Access Compliance Report

Public Rights-of-Way

(Curb Ramps)

Intersection ID: 13590	Main Street: CAMDEN_RD	Cross Street: S_TRYON_ST	Location: NE
ADA ID: 97467772CFD9	Ramp Type: Perp	Initial Pass/Fail: Pass	Overall Compliance: No
Severity Score: 0.25			
Codes/Mitigation Info/Possible Solution		Field Measurements/Component Compliance

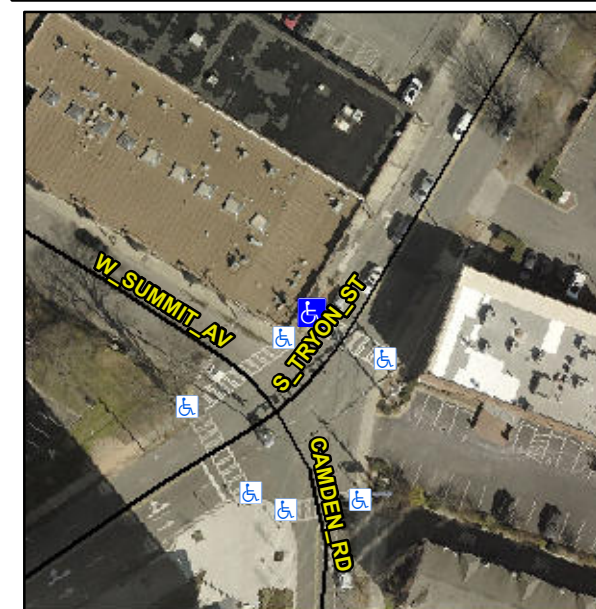
R304.5.3, R305.2

Compliance	Description	Data	Compliance	Description	Data
N/A	Ramp Length (in)	38.0	Yes	Ramp Slope (%)	6.1
Yes	Ramp Width (in)	48.0	No	Ramp XSlope (%)	2.3
N/A	Flare Type LT	Sloped	N/A	Flare Type RT	N/A
N/A	Flare Slope LT (%)	5.4	Yes	Flare Slope RT (%)	6.7
N/A	Flare Traversable LT?	Yes	N/A	Flare Traversable RT?	Yes
Yes	Landing Length (in)	71.0	Yes	DWS Provided?	Yes
Yes	Landing Width (in)	48.0	Yes	DWS Contrast?	Yes
Yes	Landing Slope (%)	0.7	Yes	DWS Length (in)	24.0
Yes	Landing X Slope (%)	2.0	Yes	DWS Full Width?	Yes
N/A	Landing Curb? (Y/N)	No	No	DWS Offset (in)	5.5
N/A	Shared Landing?	No			
Yes	Gutter Ponding?	No	Yes	Gutter Slope (%)	4.2
Yes	Gutter Lip Ht (in)	0.0	Yes	Gutter X Slope (%)	1.3
N/A	Painted X Walk1?	Yes	N/A	Painted X Walk2?	N/A
	X Walk 1 Direction	To SE		X Walk 2 Direction	N/A
N/A	X Walk 1 Width (in)	117.0	N/A	X Walk 2 Width (in)	N/A
	X Walk 1 Slope (%)	5.2		X Walk 2 Slope (%)	N/A
	X Walk 1 X Slope (%)	0.7		X Walk 2 X Slope (%)	N/A

Remove & Replace Entire Ramp.
